## PLANNING TECHNICAL REVIEW COMMITTEE –AGENDA

## PLAN SNAPSHOT REPORT WAIV-2023-0006 FOR CITY OF DOVER, N.H.

**RE: Second Street Courthouse – Site Plan Amendment  
10 Second Street  
Dover Planning File: P21-30**

**TO:** Donna Benton, Planner, City of Dover      **DATE:** 6/8/2023  
**FROM:** Neil J. Rapoza, PE  
CIVIL CONSULTANTS  
**SUBJECT:** Plan Revision Memo  
**PROJECT:** 20-279.00 One First Street, LLC (Dover project #P21-30)

EROSION  
CONTROL  
PLAN

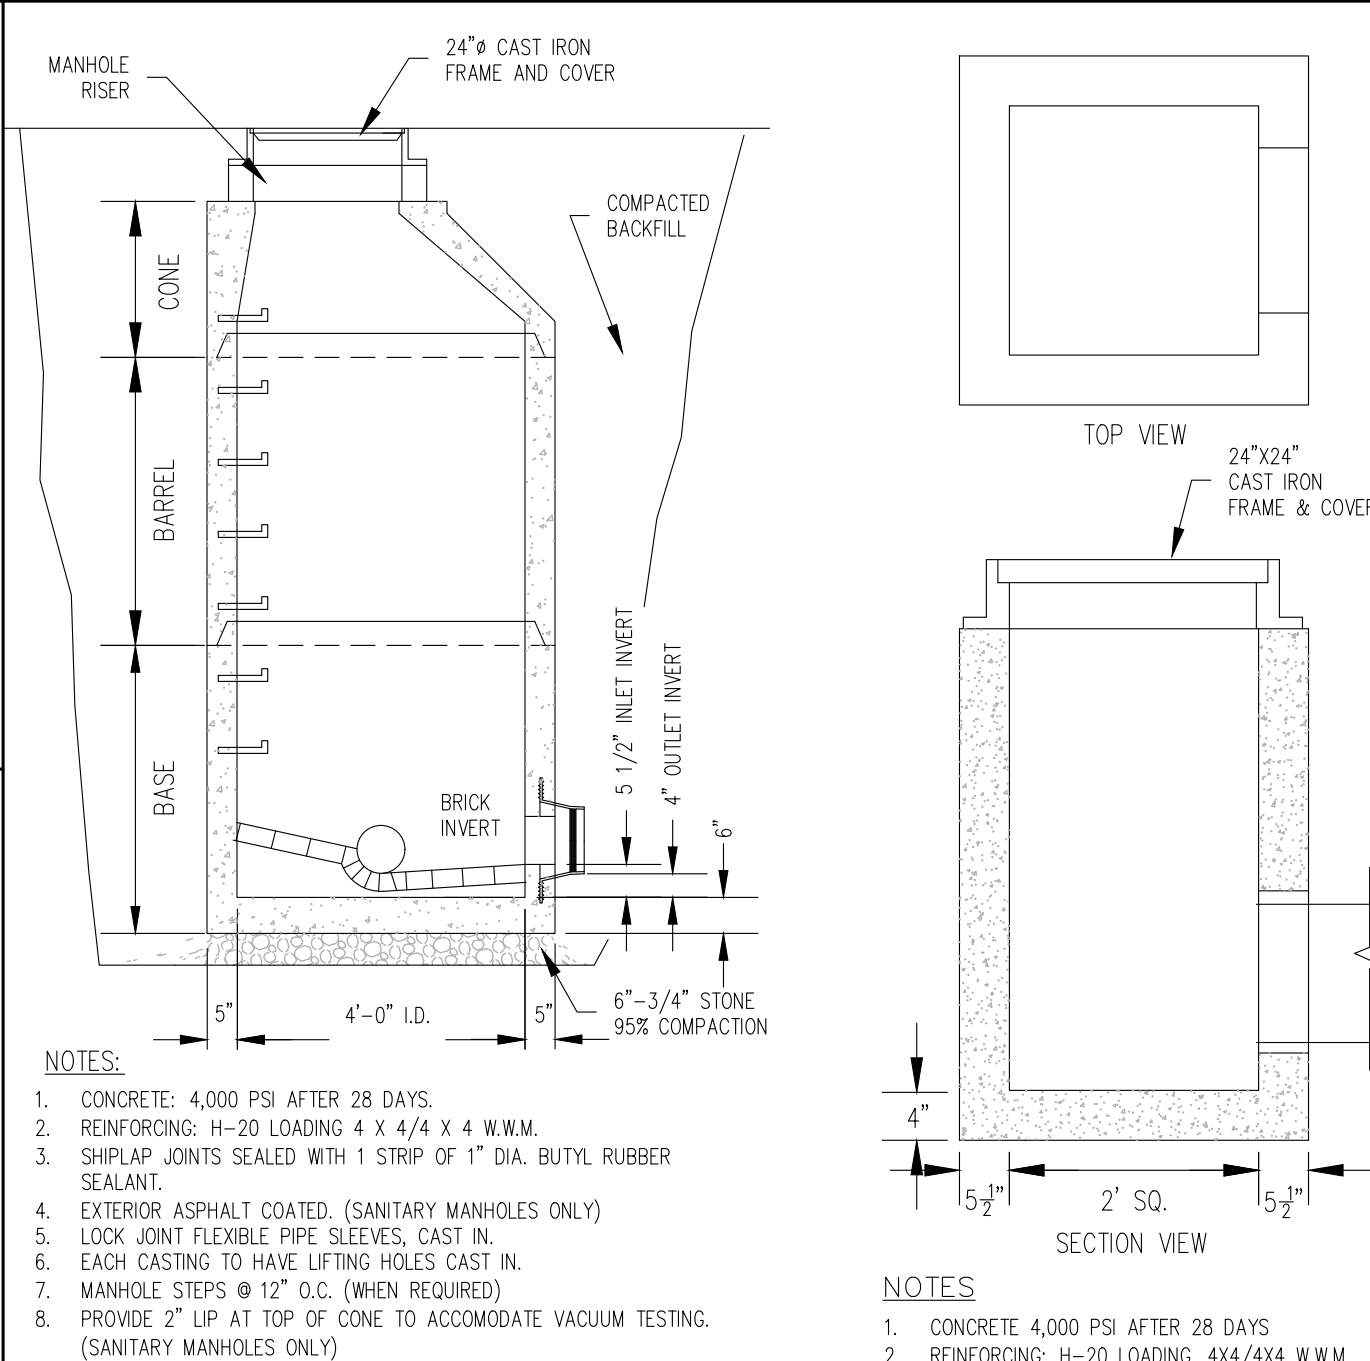
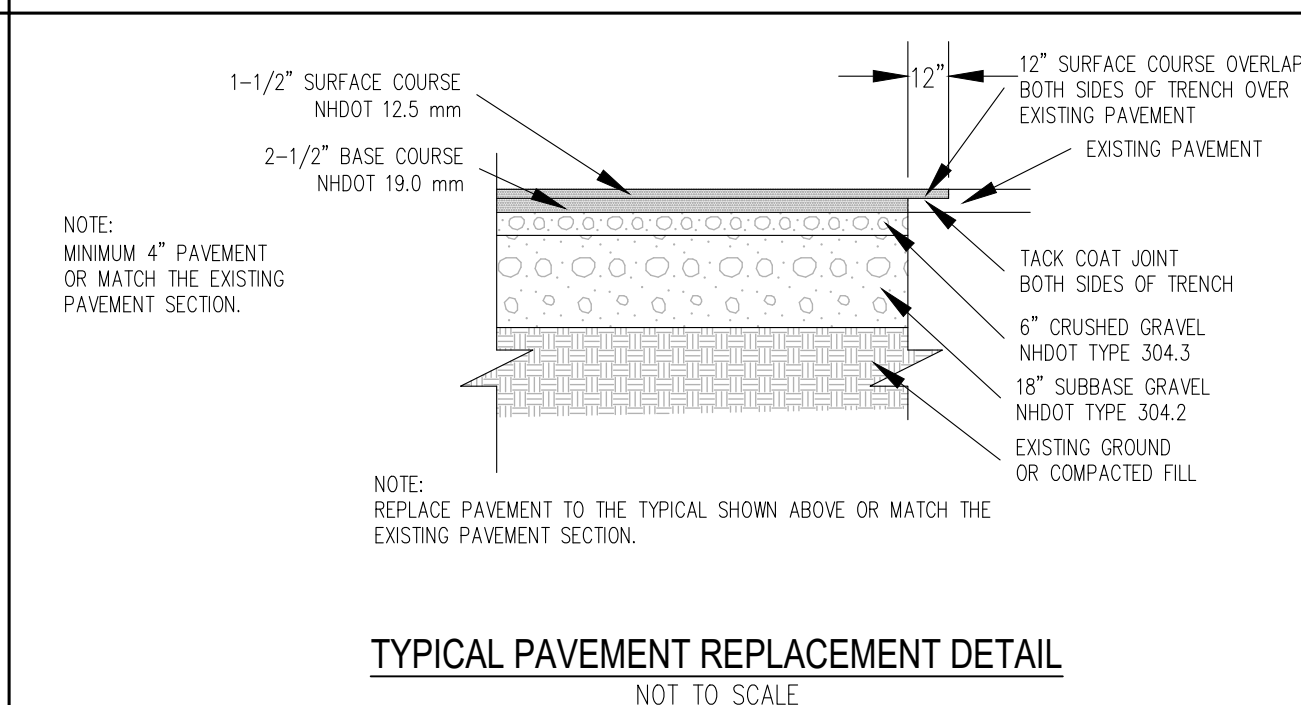
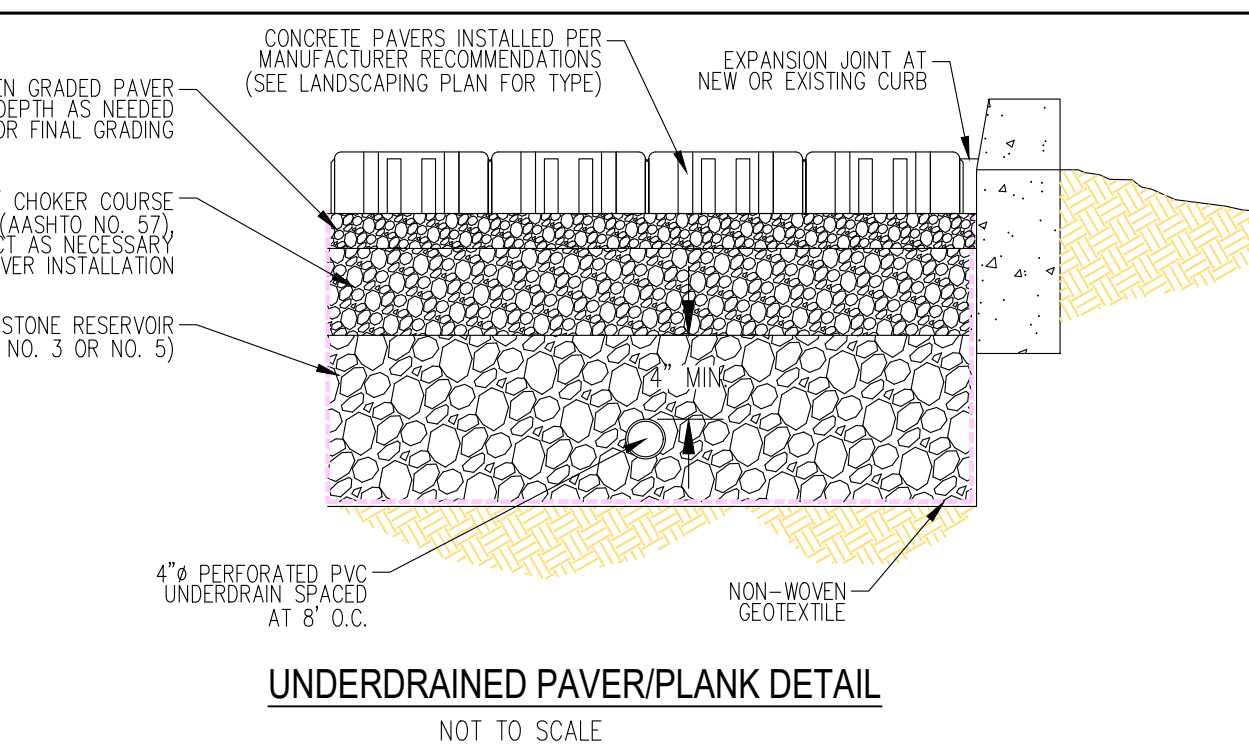
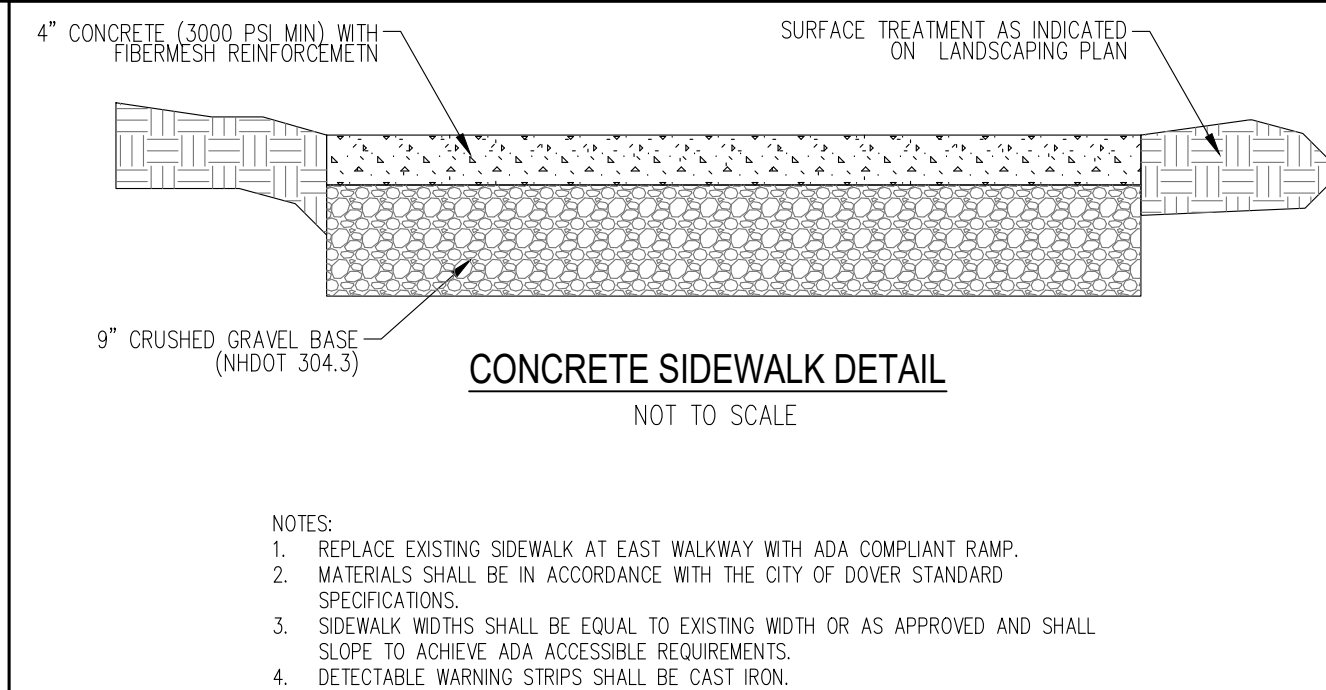
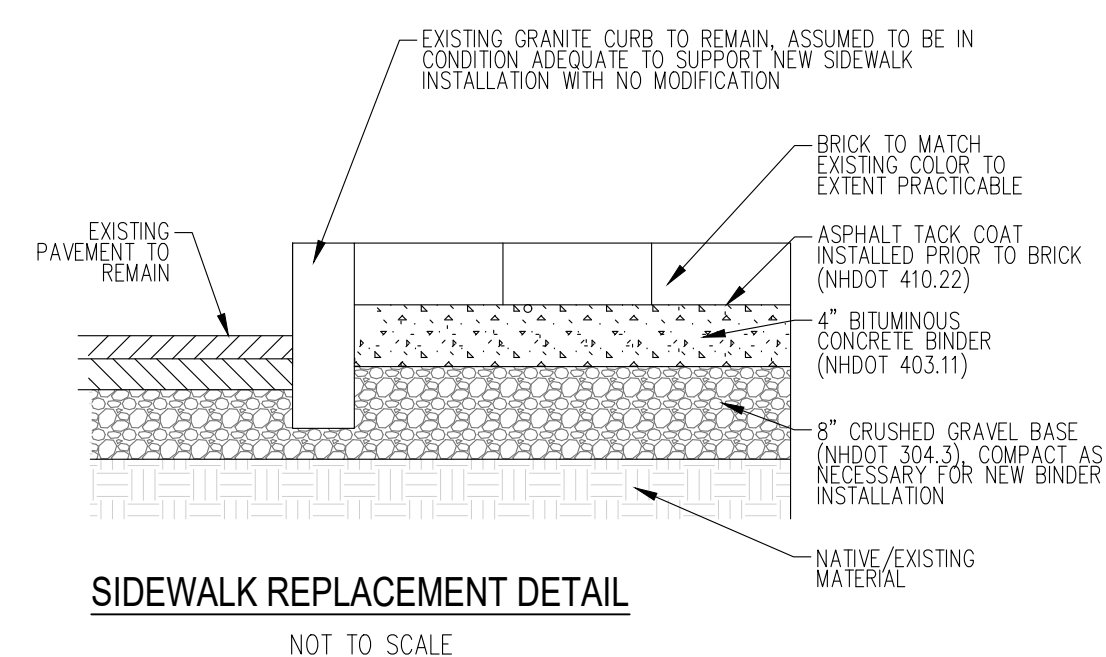
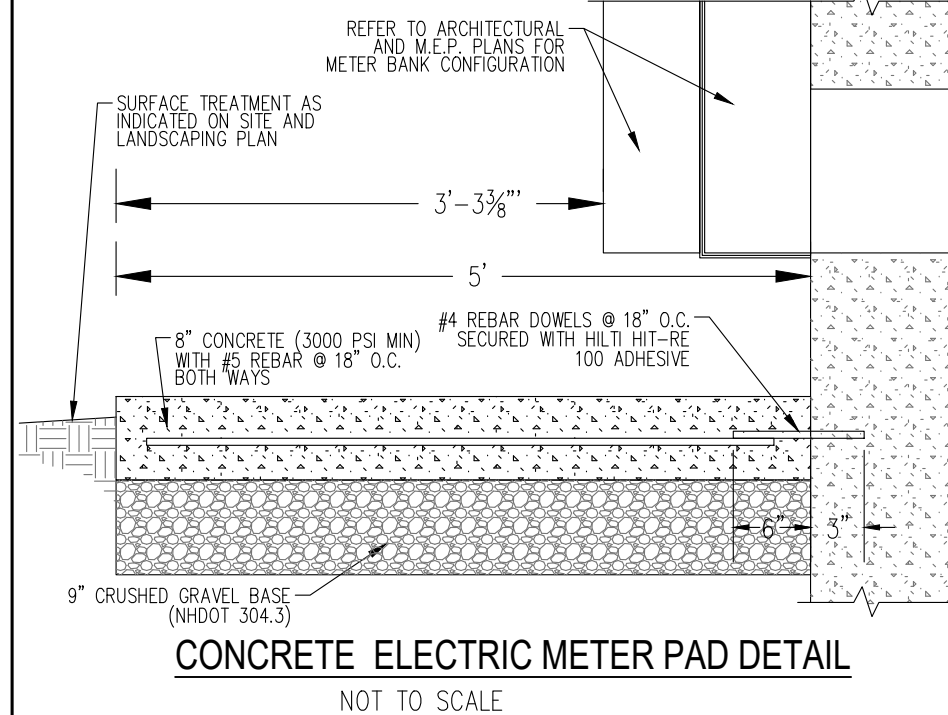
#### Sheet L6

- a. Revised stair and planter configuration at east alley to accommodate existing utilities encroaching on subject lot.
- b. Added erosion control berm to legend.
